July 23, 2002  
AEP:NRC:2349-01  
10 CFR 50.90  
10 CFR 50.61  
10 CFR 50.60(b)

SUBJECT: Donald C. Cook Nuclear Plant, Unit 2  
Docket No. 50-316  
License Amendment Request for Unit 2 Reactor Coolant  
System Pressure-Temperature Curves, and Request for  
Exemption from Requirements in 10 CFR 50.60(a) and  
10 CFR 50, Appendix G

License Amendment Request for  
Unit 2 Reactor Coolant System Pressure-Temperature Curves

FIGURE 3.4-2

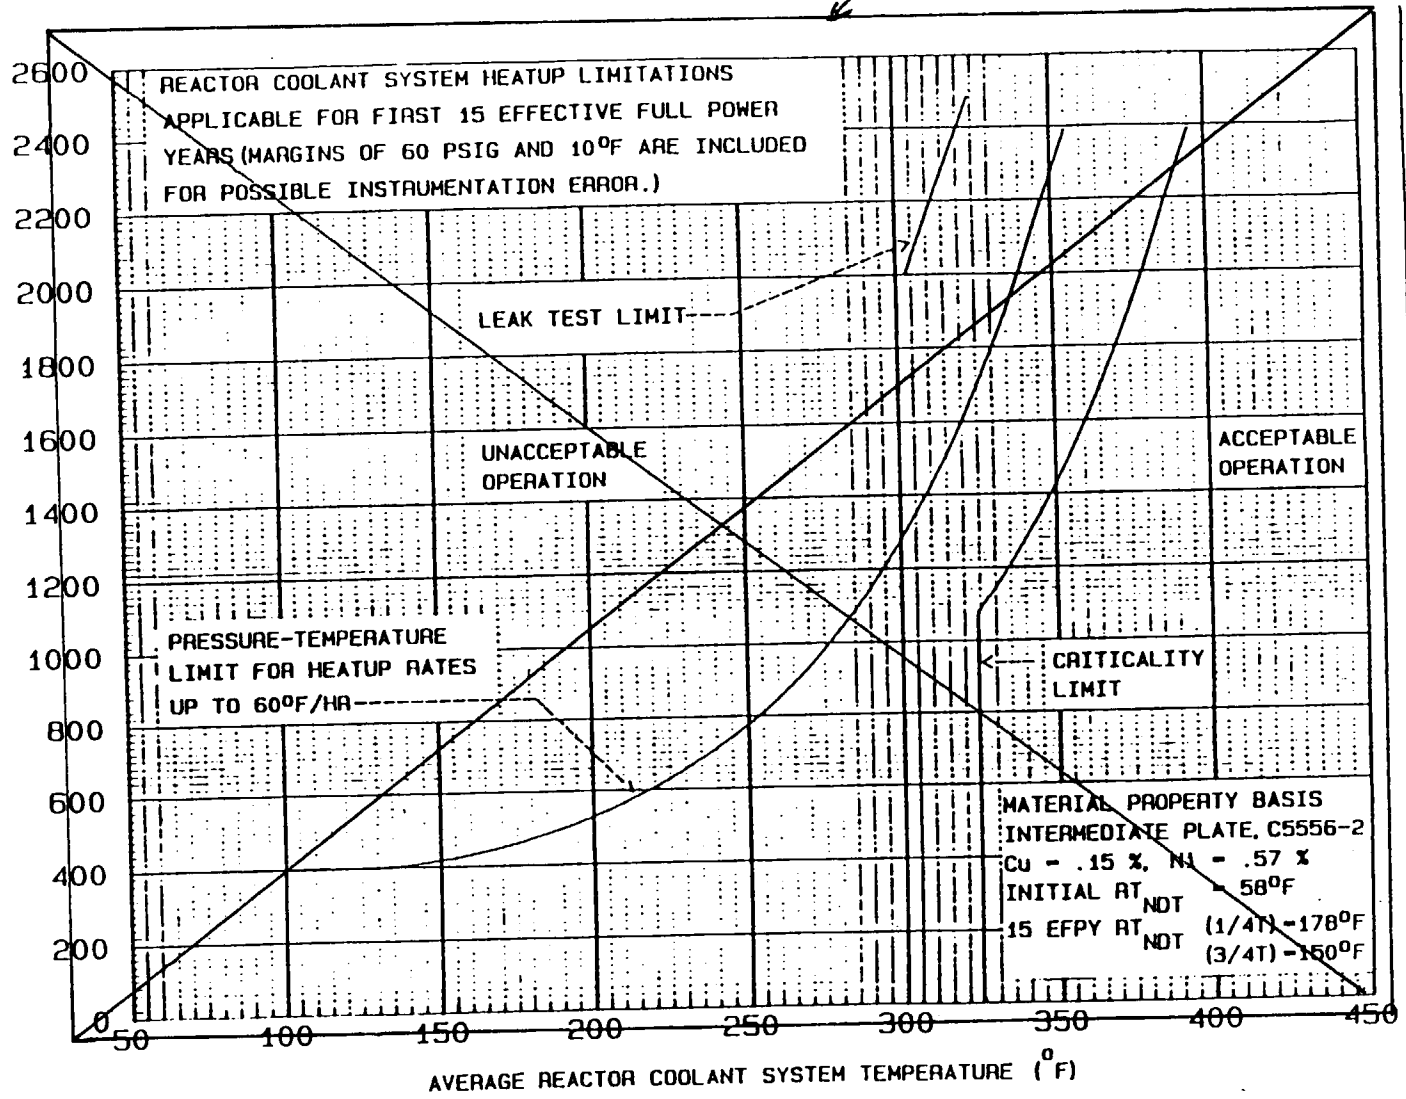
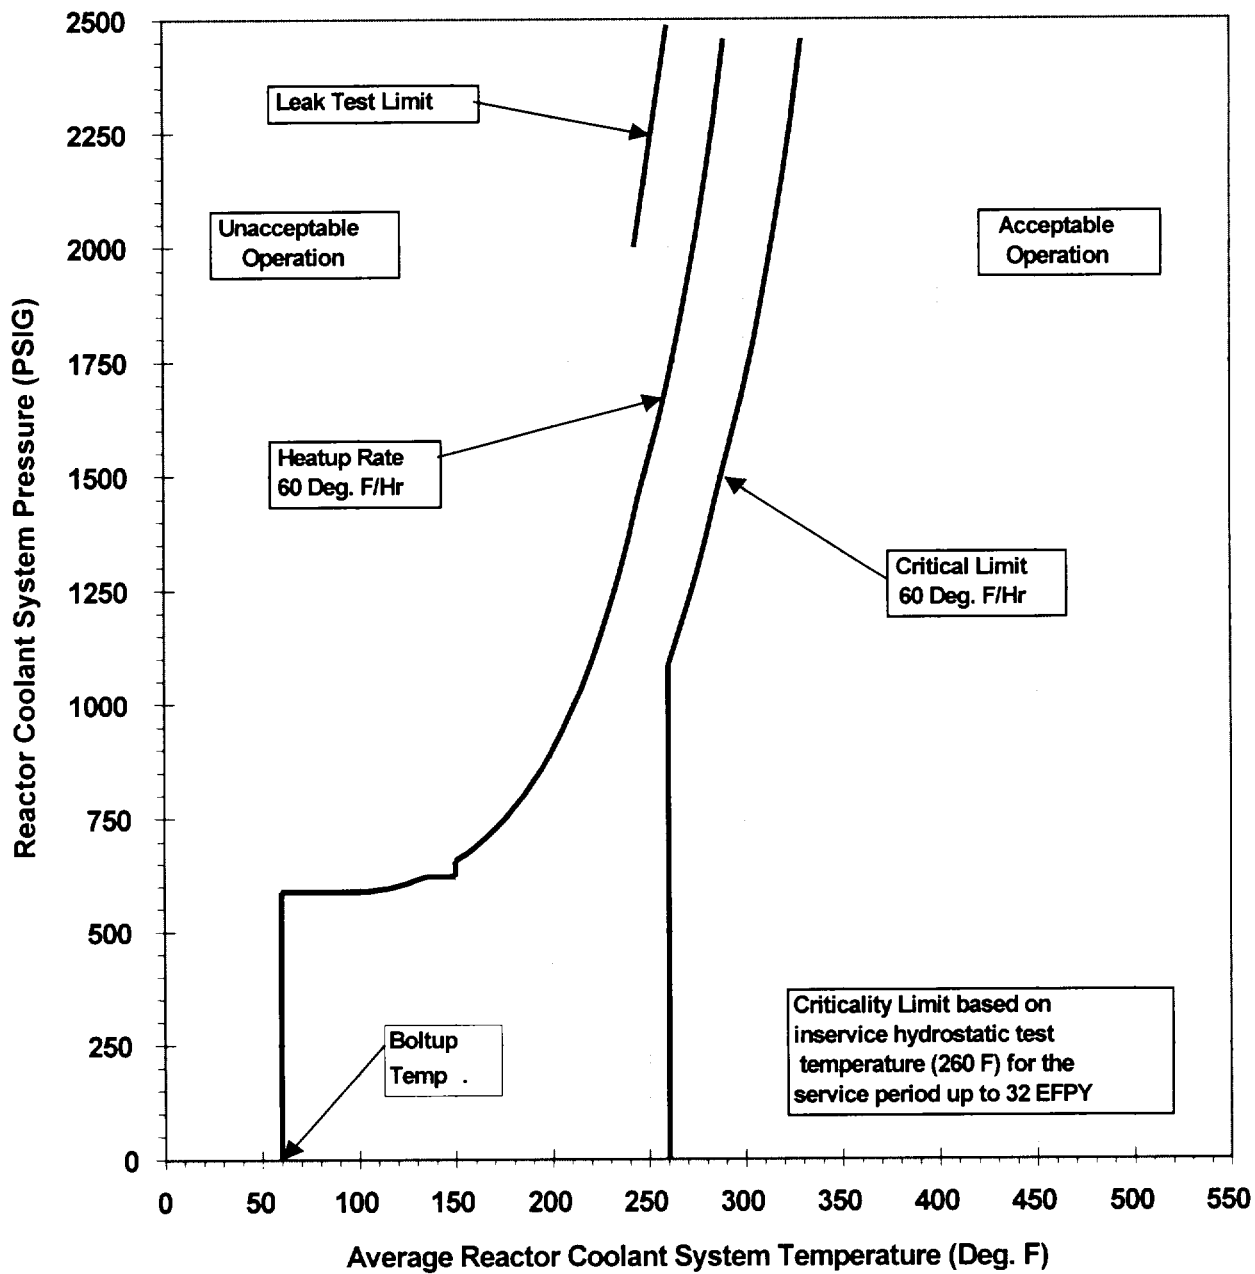
The curves in TS Figures 3.4-2 and 3.4-3 specify limits on RCS pressure and temperature for heatup, cooldown, criticality, and inservice leak and hydrostatic testing. The proposed amendment will revise these curves such that they bound operation of the reactor for up to 32 effective full power years (EFPY) at a power level of up to 3800 MWt for the current fuel cycle, Cycle 13, and beyond. The revised curves also reflect new fluence analysis methodology in accordance with Regulatory Guide (RG) 1.190 (Reference 1), reflect the use of American Society of Mechanical Engineers (ASME) Code Case N-641, include boltup limits, and do not include instrument uncertainty margins. The proposed amendment will also change the titles, labels, and orientation of TS Figures 3.4-2 and 3.4-3 and the TS Bases for Section 3/4.4.9 to be consistent with the revised curves.

Use of the new fluence analysis methodology specified in RG 1.190 and Code Case N-641 of Section XI of the ASME Code has resulted in pressure-temperature curves that are less restrictive than the curves provided in the current TS. Unlike the current RCS pressure temperature curves, the curves proposed as revisions to TS Figures 3.4-2 and 3.4-3 do not include a margin for instrument uncertainty. This is consistent with the NRC approved methodology documented in WCAP 14040-NP-A (Reference 4). Instrument uncertainty margins are incorporated in RCS pressure-temperature limits specified in plant procedures. Also unlike the current RCS pressure temperature curves, the curves proposed as revisions to TS Figures 3.4-2 and 3.4-3 include limits for bolting the RPV head. Inclusion of the boltup limits is consistent with WCAP 14040-NP-A.

REACTOR COOLANT SYSTEM, PRESSURE - TEMPERATURE, LIMITS FOR 60 °F/HR RATE, CRITICALITY LIMIT, AND ~~HYDROSTATIC TEST LIMIT~~

↪ , BOLTUP LIMIT, AND LEAK TEST LIMIT

Reactor Coolant System Heatup Limitations Without Margins for Instrumentation Error  
Applicable for 32 EFPY of Operation  
Limiting Material: Intermediate Shell Plate C5556-2, Cu = 0.15%, Ni = 0.57%  
Initial ART: 58 Deg. F, Limiting ART Values at 32 EFPY: 1/4T = 200 Deg. F, 3/4T = 169 Deg. F

FIGURE 3.4-3

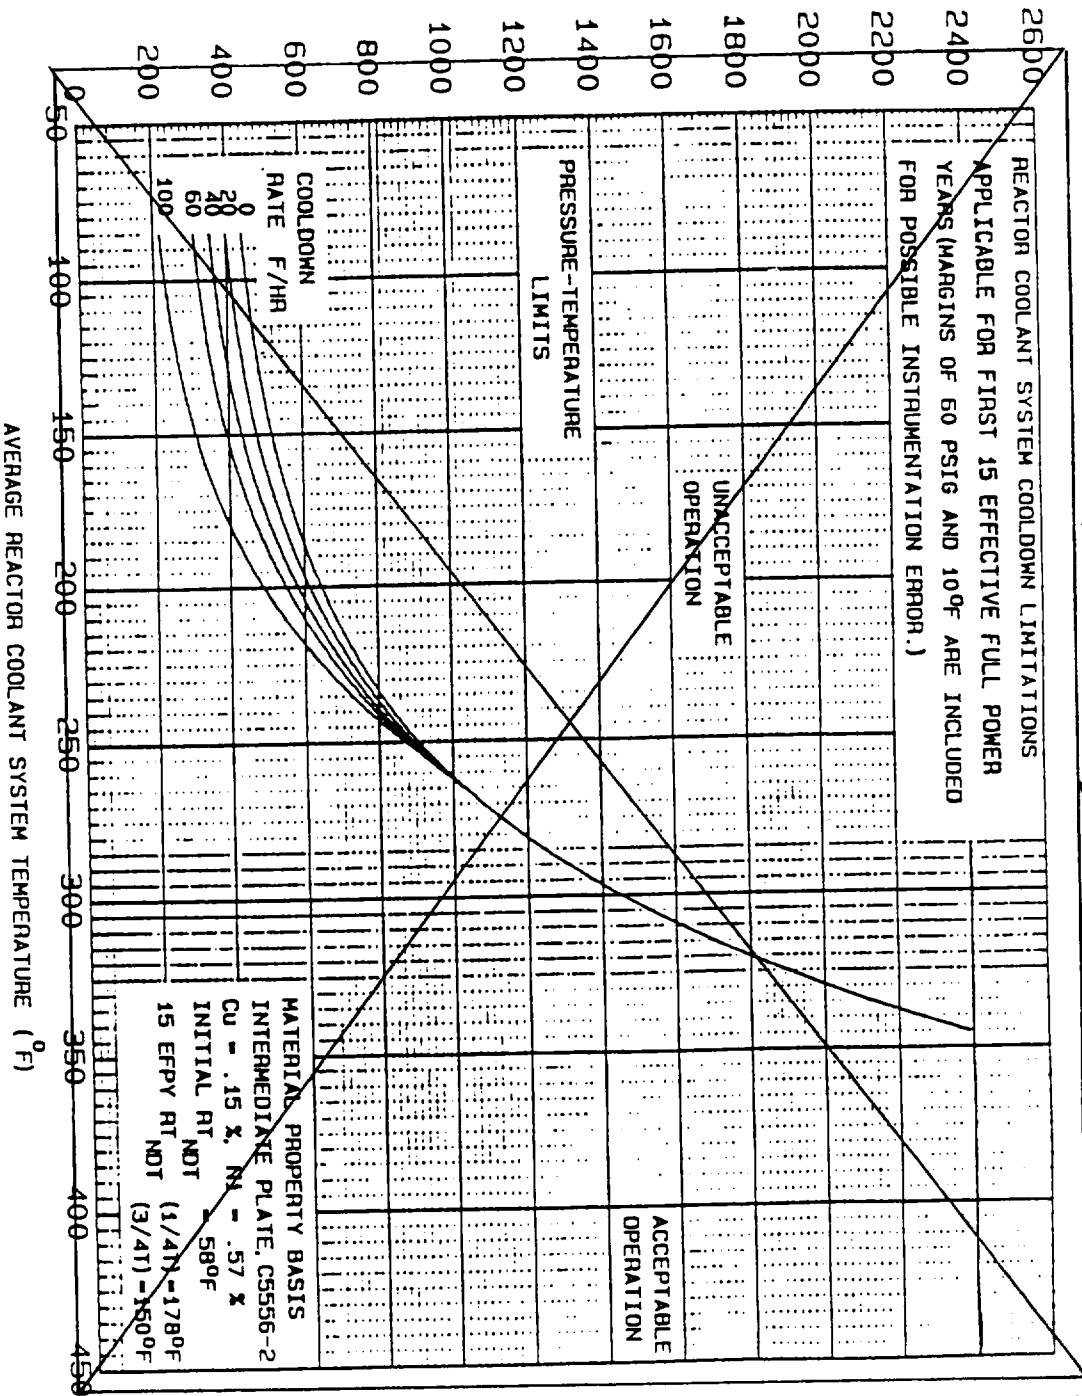
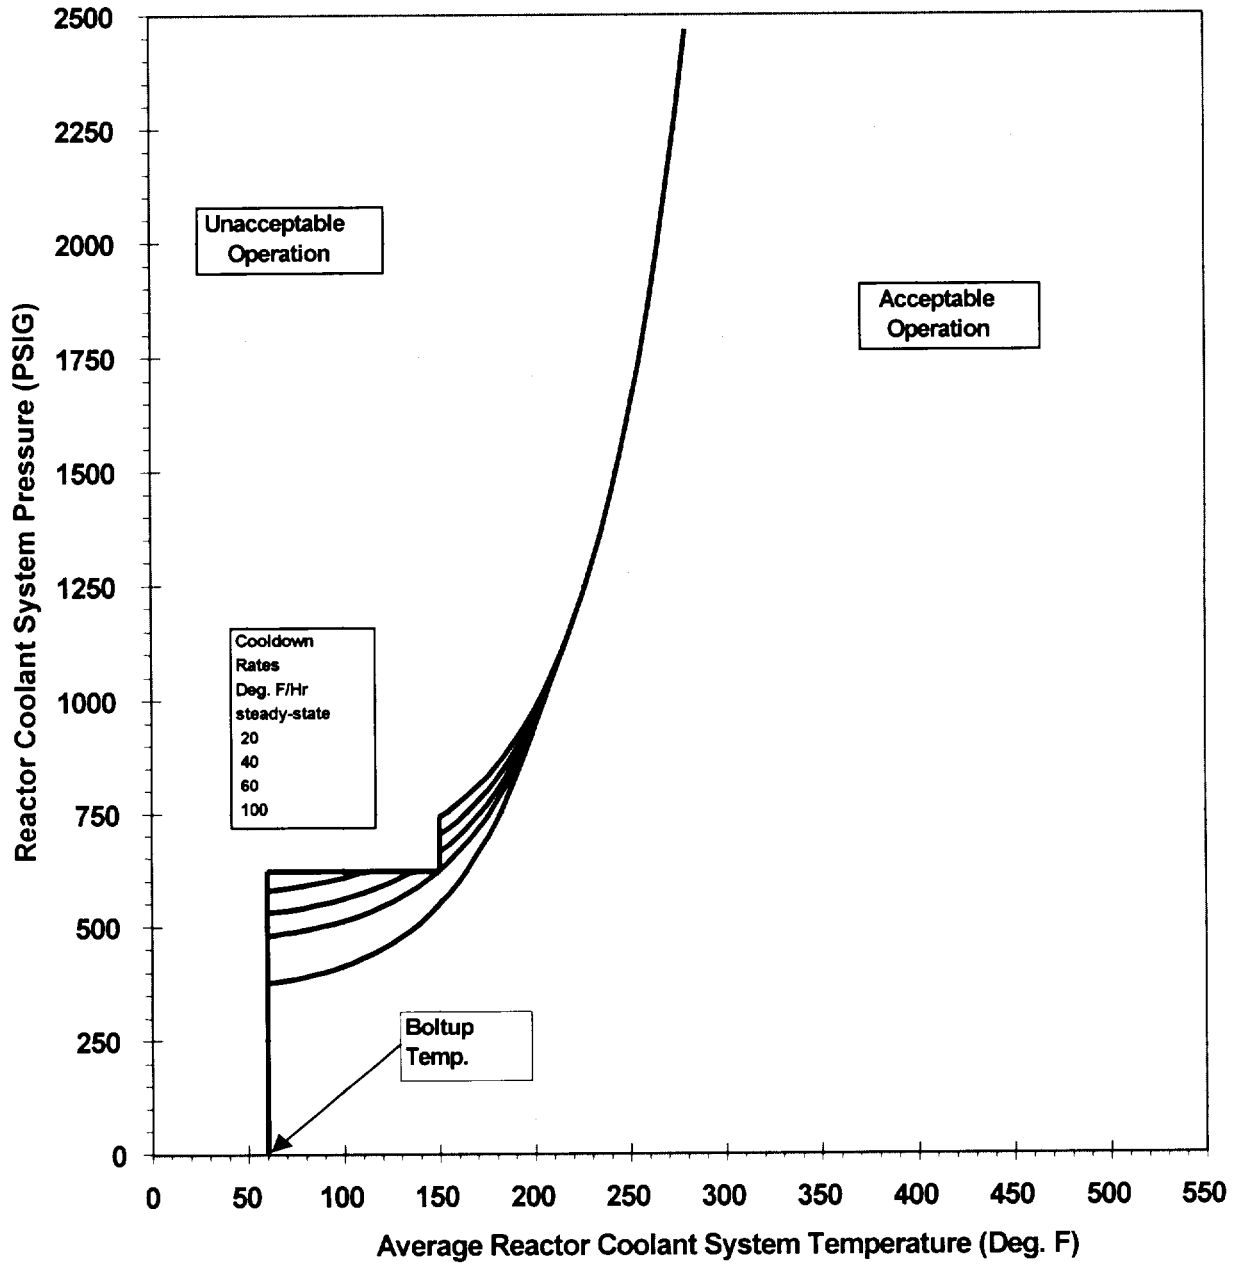
REACTOR COOLANT SYSTEM, PRESSURE - TEMPERATURE LIMITS FOR VARIOUS COOLDOWN RATES

See Insert 2

Reactor Coolant System Cooldown Limitations Without Margins for Instrumentation Error  
Applicable for 32 EFPY of Operation  
Limiting Material: Intermediate Shell Plate C5556-2, Cu = 0.15%, Ni = 0.57%  
Initial ART: 58 Deg. F, Limiting ART Values at 32 EFPY: 1/4T = 200 Deg. F, 3/4T = 169 Deg. F

FIGURE 3.4-2  
 REACTOR COOLANT SYSTEM PRESSURE - TEMPERATURE LIMITS FOR  
 60°F/HR RATE, CRITICALITY LIMIT, BOLTUP LIMIT, AND LEAK TEST LIMIT

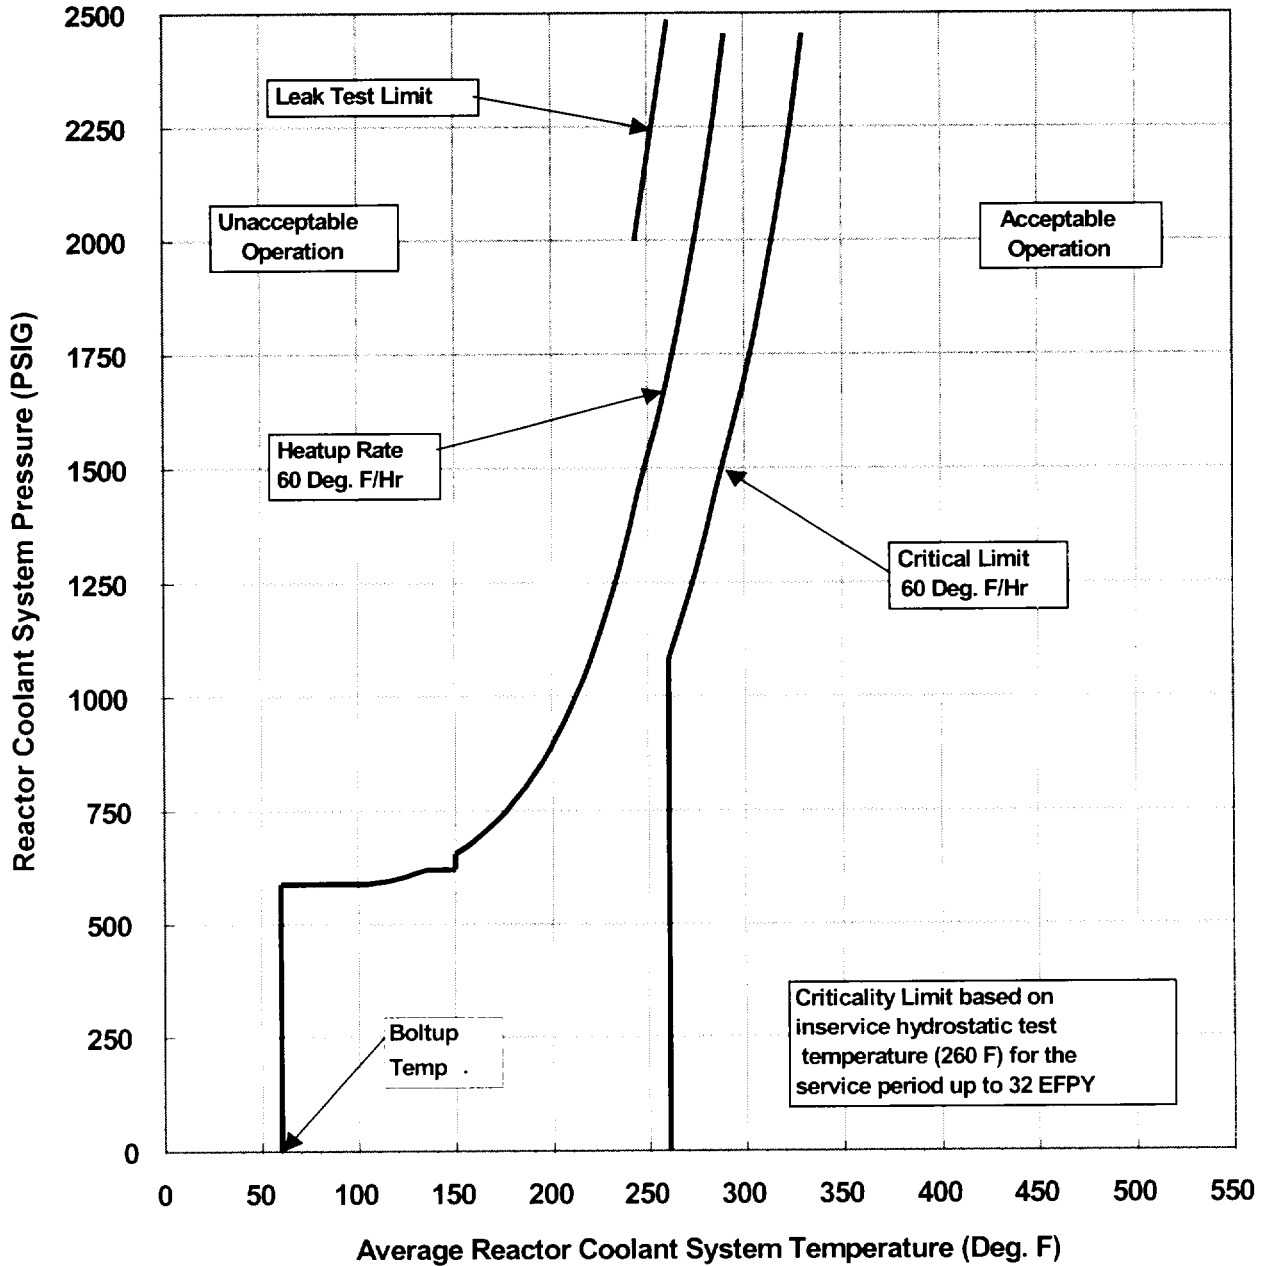
The proposed amendment would revise TS Figures 3.4-2 and 3.4-3, and their associated Bases. The curves in these figures specify limits on RCS pressure and temperature during heatup, cooldown, criticality and inservice leak and hydrostatic testing.

Reactor Coolant System Heatup Limitations Without Margins for Instrumentation Error  
 Applicable for 32 EFY of Operation  
 Limiting Material: Intermediate Shell Plate C5556-2, Cu = 0.15%, Ni = 0.57%  
 Initial ART: 58 Deg. F, Limiting ART Values at 32 EFY: 1/4T = 200 Deg. F, 3/4T = 169 Deg. F
